AIRCRAFT ENGINES

NEW CHARGING COIL ASSY. WITH SUPPORT

FOR ROTAX® ENGINE TYPE 505

SB-505-009 R1

fig. 1

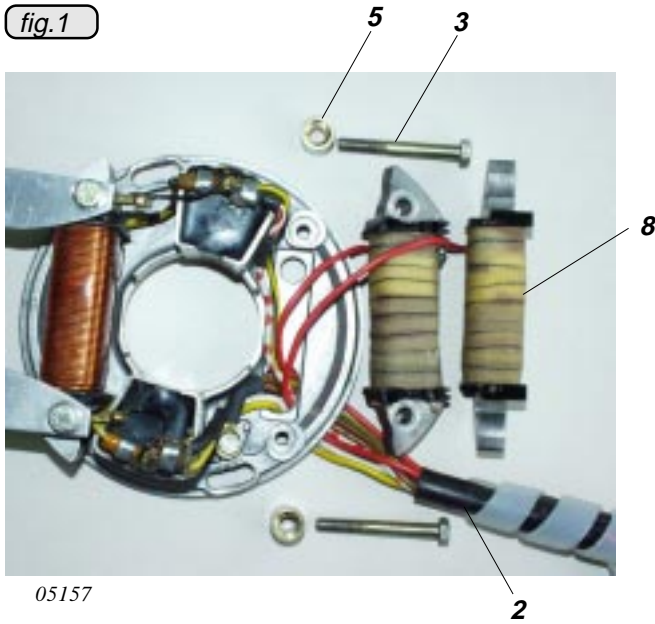
- Draw in the red charging cable (6) by a commonly used trace-wire through the insulation hose (2) or screening braid and position the charging coil (8) on the armature plate (1) (see fig. 1).

fig. 2

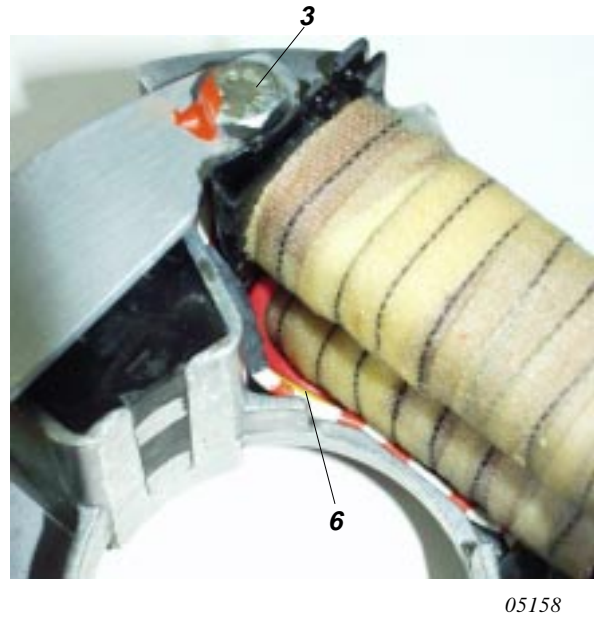
■ **CAUTION:** To prevent squeezing of the charging cables (6) route the cables parallel below the charging coil (8) (see fig. 2).

fig. 3

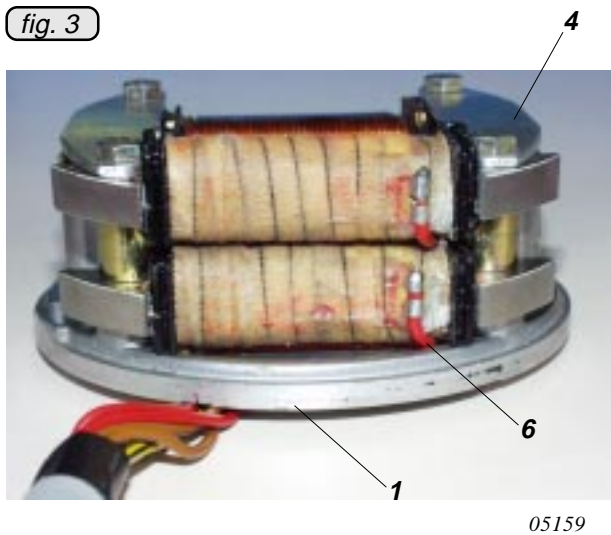
■ **CAUTION:** On the new charging coil (8) the wiring direction of the coil have been turned round, therefore the positioning (position of the charging cable 6) need to be followed as shown in fig. 3. At wrong installed charging coil no high tension output of the relevant electronic box and therefore no ignition spark will be created.

fig. 5

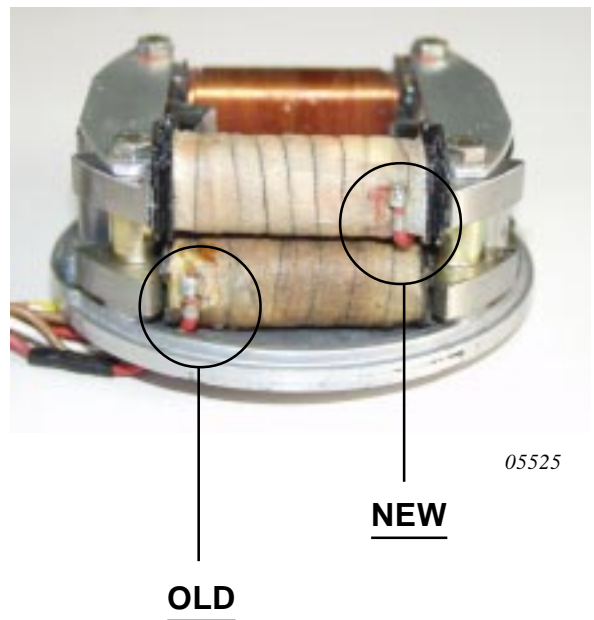
◆ NOTE: Because of changed wiring at the new type charging coil assy the charging cable soldering point is opposit on the right side (see fig. 5).

If an old type and a new type charging coil is fitted together as a working pair, the charging cable soldering point's are at the opposite side (see fig. 5).
